# Design and Application of a Multi-Hazard Risk Rapid Assessment Questionnaire for Hill Communities in the Indian Himalayan Region

Shivani Chouhan<sup>1\*</sup>, Mahua Mukherjee<sup>2</sup>

109 *Figure 1: Indian Himalayan Region, Source: adapted from (NMHS, n.d.) (Mohammad Imran Siddique, Jayesh*  
110 *Desai, Himanshu Kulkarni, 2019)*

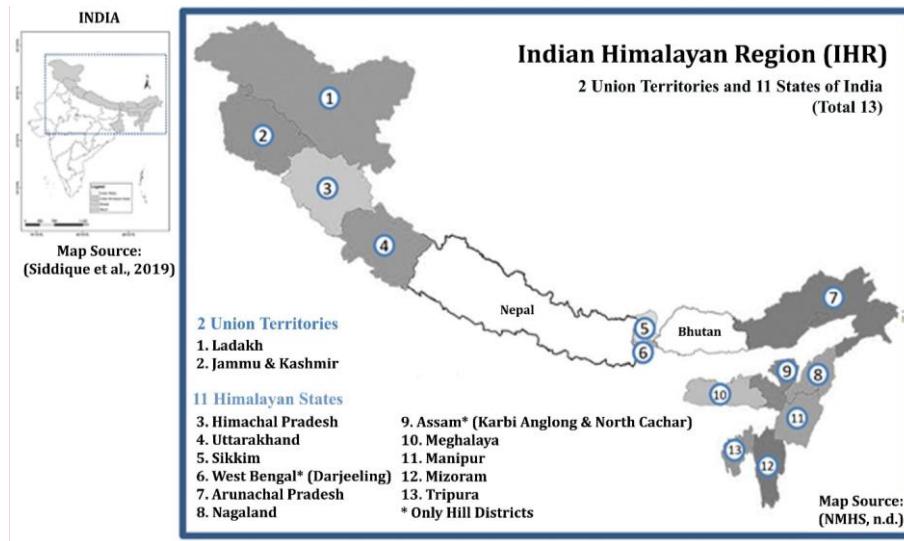
**Commented [SS5]:** Comment (R1)-4: In line 92, There are two Union Territories not one accordingly modification are needed in text.

**Commented [SS8]:** Comment (R1)-4: In line 92, There are two Union Territories not one accordingly modification are needed in text.

**Response:** We appreciate the reviewer's insightful observation and taking this comment into consideration, we have updated it in text as well as in figure 1.

**Response:** We appreciate the reviewer's insightful observation and taking this comment into consideration, we have updated it in text as well as in figure 1.

Figure 2: Methodology adopted *by author*

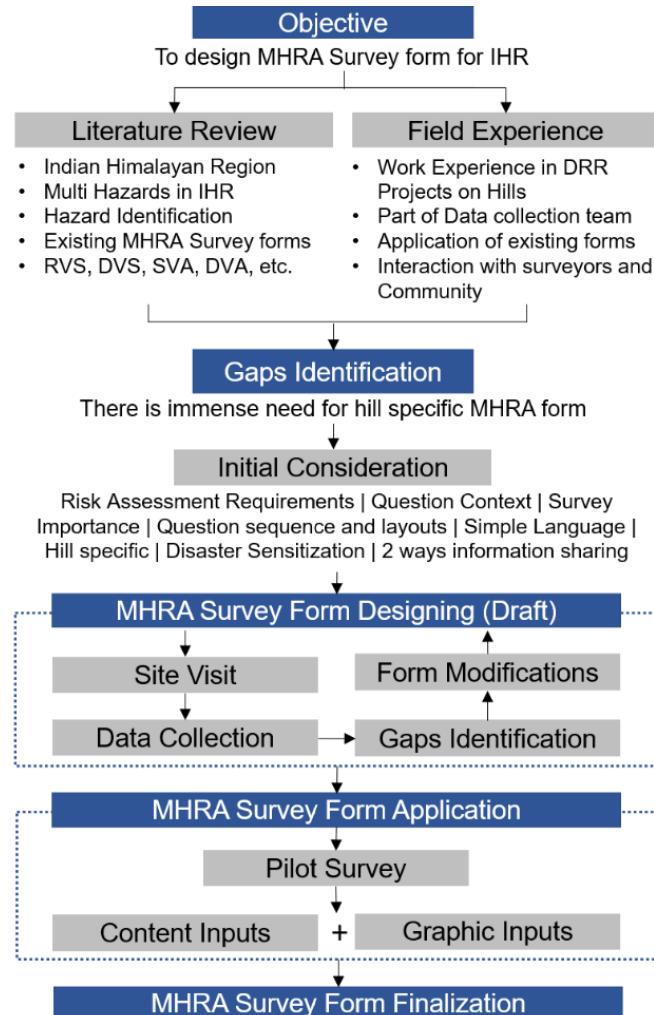
**Commented [SS13]:** Comment (R1)-11.2: (ii) Write details as per steps of your methodology given in figure 2, in sequence.

**Response:** We appreciate the reviewer's insightful suggestion. I would like to highlight that the methodology is already explained in section 3.2, and detail of every step is explained in section 4.
